4155C-05

S E R V I C E N O T E

4155C Semiconductor Parameter Analyzer
4156C Precision Semiconductor Parameter Analyzer

LCD Picture Intermittently Reverses or is not Displayed

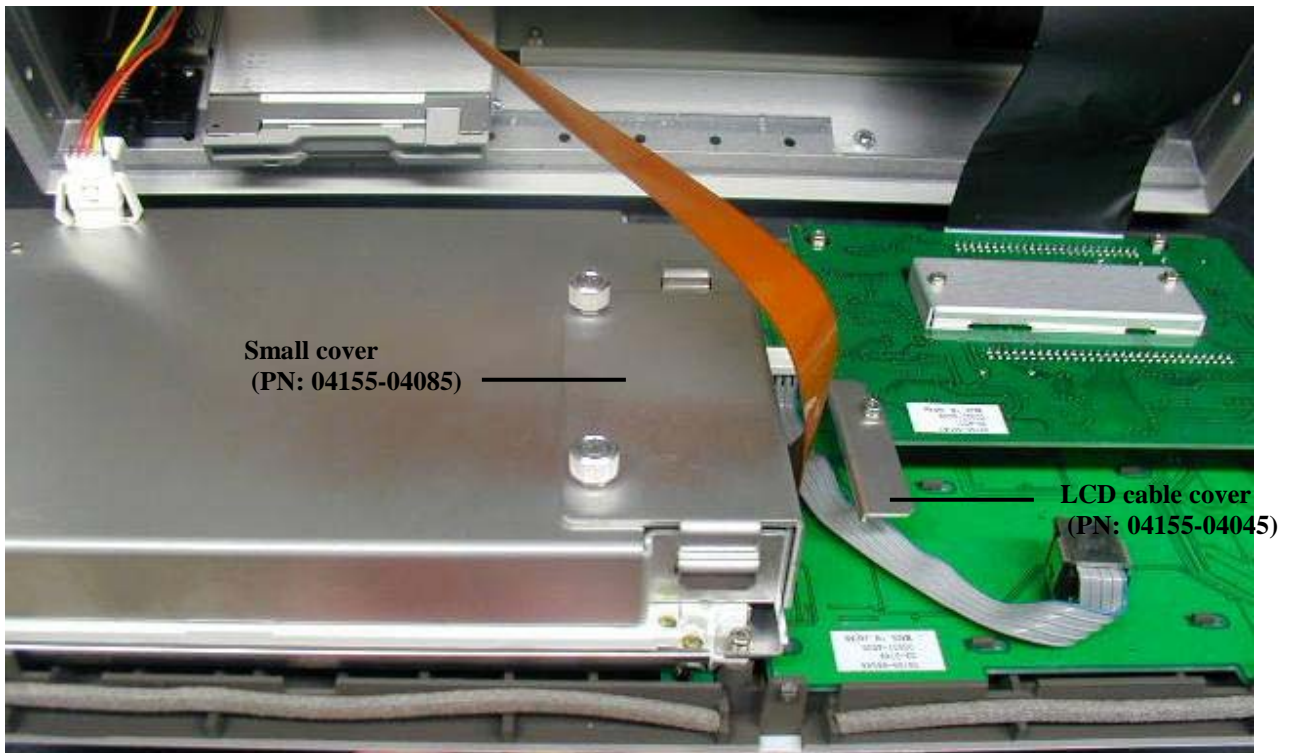
The 4155C within the listed serial number range may have the problem that the LCD picture intermittently reverses or is not displayed. The cause of the problem is that the PC board stresses the LCD cable, and the cable connection becomes loose. Though we have released service note 4155C-04 and 4156C-04, it is not enough.

After adapting service note 4155C-04 or 4156C-04, replace the original cable cover (small: 04155-04085) with a set of 04155-24060, 04155-04086, and 04155-04087. To replace with this set, the flexible video cable will be fixed enough.

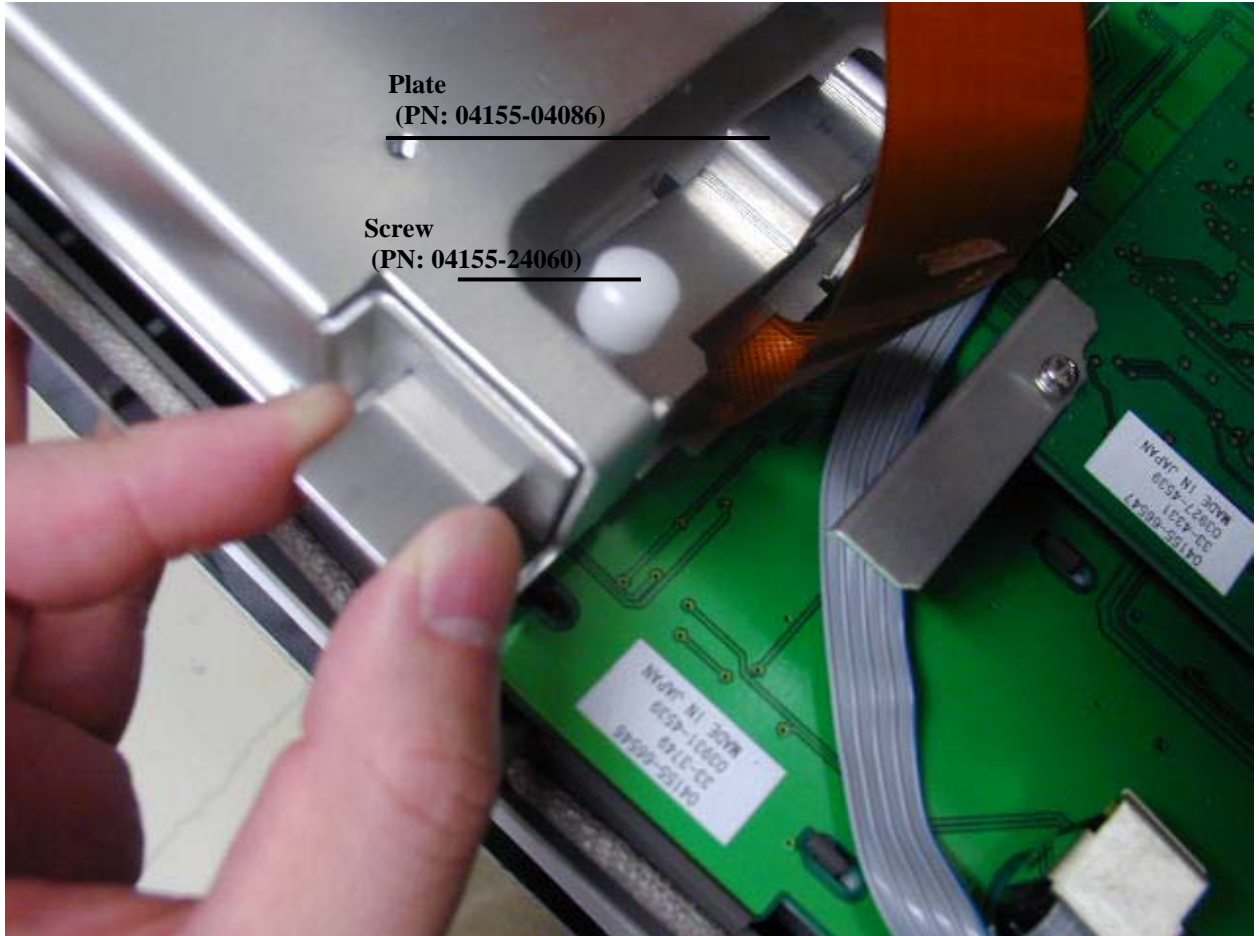
3. Remove the original small cover 04155-04085

4. Insert the plate (PN: 04155-04086) and fix it using screw (PN: 04155-24060).

5. Install the new small cover (PN: 04155-04086).
6. Perform the diagnostics Interactive Test “LCD Test”.
